v1.1 : Replace the 74LVC244AAQ20 by 74LVCH244AQ20.

Schematic	Schematics			Create at	2026-01-23
Board	Board1			Update at	2026-03-28
Drawn	BtPluggy			Page	P1
Reviewed					
			Version	Size	Page 1 Total 1
EasyEDA			V1.0	A4	EasyEDA.com

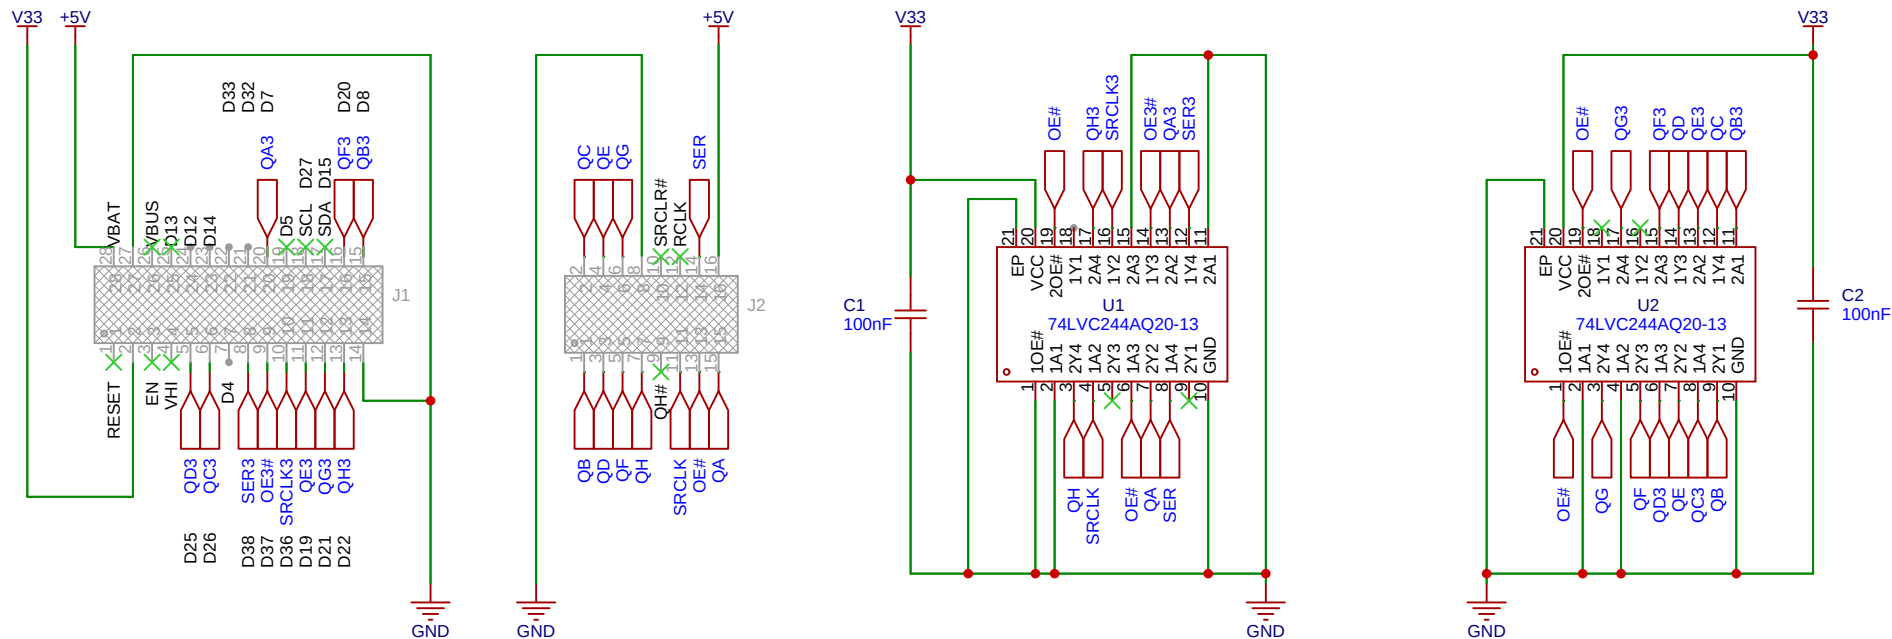
The LVCH bus hold feature prevents spurious interrupts when the device is powered from the USB port and not plugged into a powered Gigatron.
